# Access Compliance Report

## Public Rights-of-Way

### (Curb Ramps)

Intersection ID: 10026777	Main Street: FOREST_CROSS_DR	Cross Street: N/A	Location:	N
ADA ID: DF2929321DF9	Ramp Type: Perp	Initial Pass/Fail: Fail	Overall Compliance: No	Severity Score: 25
Codes/Mitigation Info/Possible Solution		Field Measurements/Component Compliance

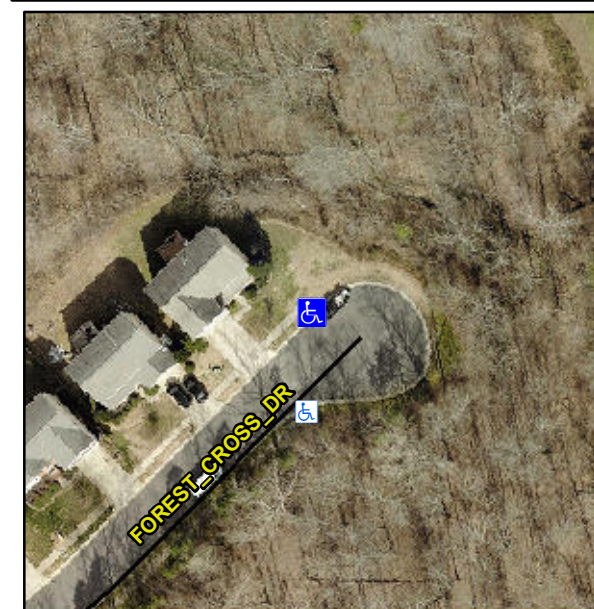
**Not Found, R304.2.2, R304.5.3**

Compliance	Description	Data	Compliance	Description	Data
N/A	Ramp Length (in)	48.0	No	Ramp Slope (%)	8.5
Yes	Ramp Width (in)	55.0	No	Ramp XSlope (%)	6.3
N/A	Flare Type LT	N/A	N/A	Flare Type RT	N/A
N/A	Flare Slope LT (%)	N/A	N/A	Flare Slope RT (%)	N/A
N/A	Flare Traversable LT?	N/A	N/A	Flare Traversable RT?	N/A
N/A	Landing Length (in)	N/A	N/A	DWS Provided?	N/A
N/A	Landing Width (in)	N/A	N/A	DWS Contrast?	N/A
N/A	Landing Slope (%)	N/A	N/A	DWS Length (in)	N/A
N/A	Landing X Slope (%)	N/A	N/A	DWS Full Width?	N/A
N/A	Landing Curb? (Y/N)	N/A	N/A	DWS Offset (in)	N/A
N/A	Shared Landing?	N/A			
N/A	Gutter Ponding?	N/A	N/A	Gutter Slope (%)	N/A
N/A	Gutter Lip Ht (in)	N/A	N/A	Gutter X Slope (%)	N/A
N/A	Painted X Walk1?	No	N/A	Painted X Walk2?	N/A
	X Walk 1 Direction	To S		X Walk 2 Direction	N/A
N/A	X Walk 1 Width (in)	N/A	N/A	X Walk 2 Width (in)	N/A
	X Walk 1 Slope (%)	2.8		X Walk 2 Slope (%)	N/A
	X Walk 1 X Slope (%)	1.7		X Walk 2 X Slope (%)	N/A

**Remove & Replace Entire Ramp.**
